Vogtle Electric Generating Plant - Unit 1 (VEGP-1)
Inservice Inspection (ISI) Program
First 10-Year Interval
(ISI-P-006)

Revision 4 Summary of Changes

ATTACHMENT 1

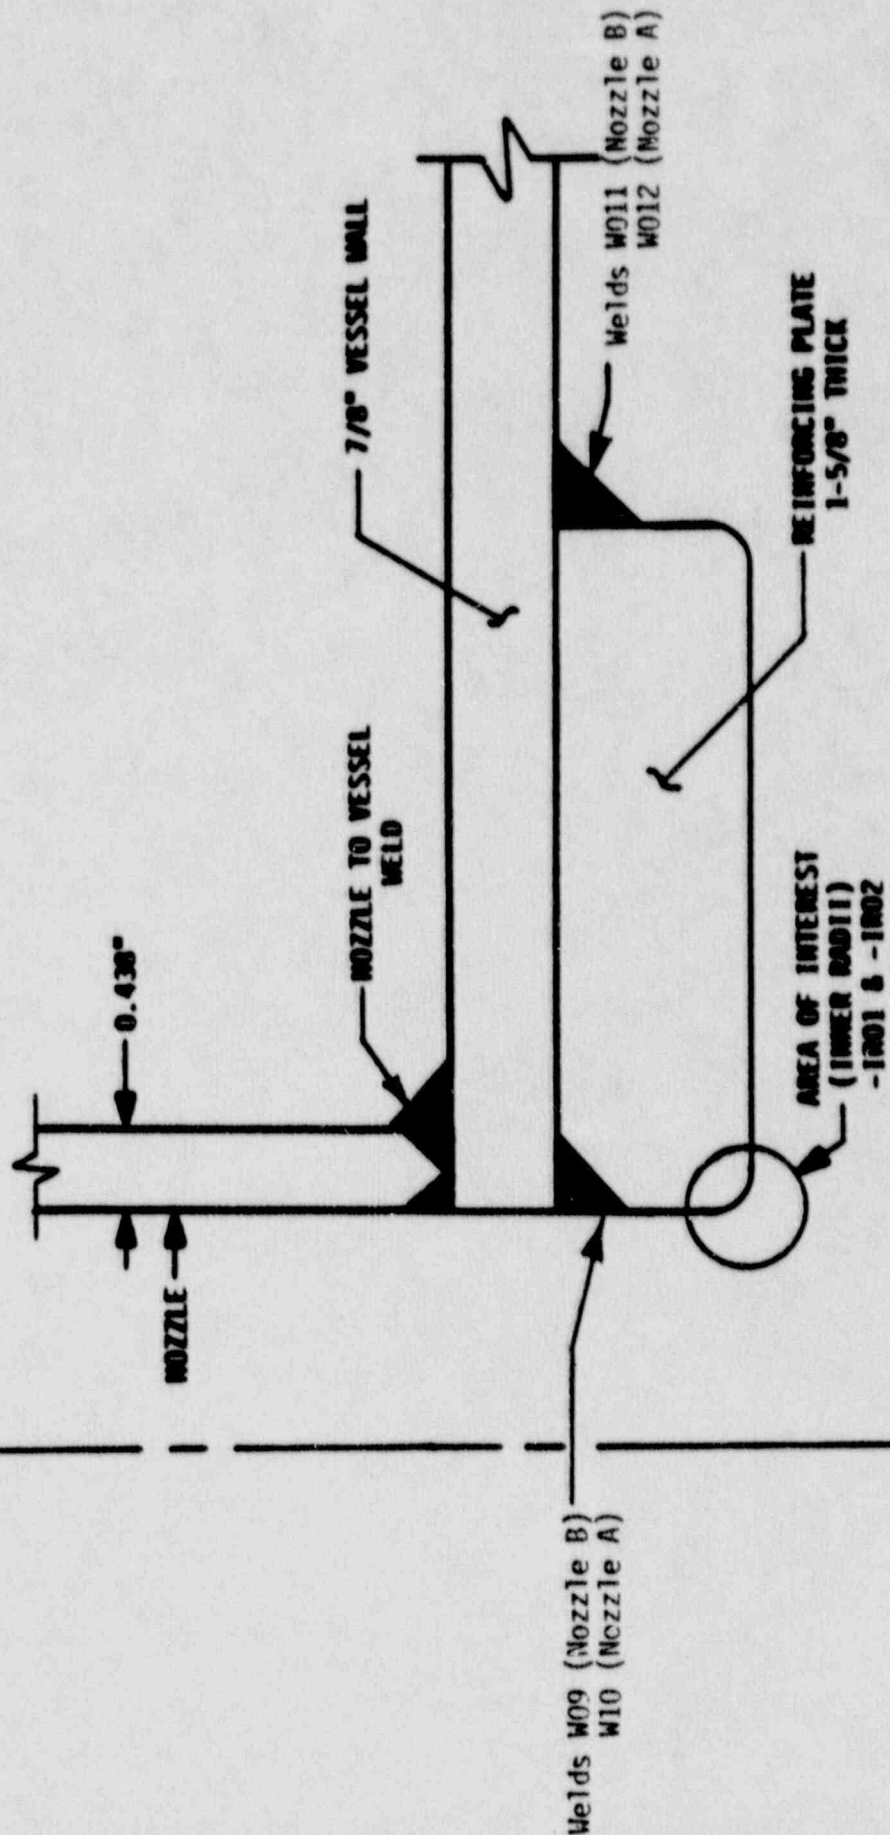
Relief Request RR-32 has been revised to include the surface examination of the reinforcing plate-to-vessel welds in the Residual Heat Removal System heat exchangers and to elaborate upon the relief requested. In addition, the figure accompanying the relief request has been revised to better depict the configuration at VEGP-1. The revised relief request is similar in content to RR-32 for VEGP-2.

- (2) Figure No. IWC-2500-4(c) of ASME Section XI which constitutes the examination requirement for Examination Area Identification Numbers W09, W10, W011, and W012 does not illustrate the reinforcing plate-to-vessel design of the VEGP-1 RHR Heat Exchangers. Refer to Attachment 1 for the VEGP-1 configuration. The reinforcing plate at VEGP-1 is welded to the inside diameter of the heat exchanger wall with no nozzle-to-reinforcing plate contact (welds). The reinforcing plate-to-vessel welds are inaccessible. Therefore, it is impractical to perform a surface examination on the reinforcing plate-to-vessel welds W09, W10, W011, and W012 due to their inaccessibility.

- (2) Due to their inaccessibility, no surface examination of the reinforcing plate-to-vessel welds W09, W10, W011, and W012 can be performed. No alternate examination, e.g., volumetric examination, can be performed or is proposed due to the configuration involved. The interface between the reinforcing plate and the RHR heat exchanger vessel wall precludes an adequate volumetric examination from being performed for the aforementioned welds. No compensating increase in the level of quality and safety would be realized should an alternate examination, e.g., volumetric examination, be performed.
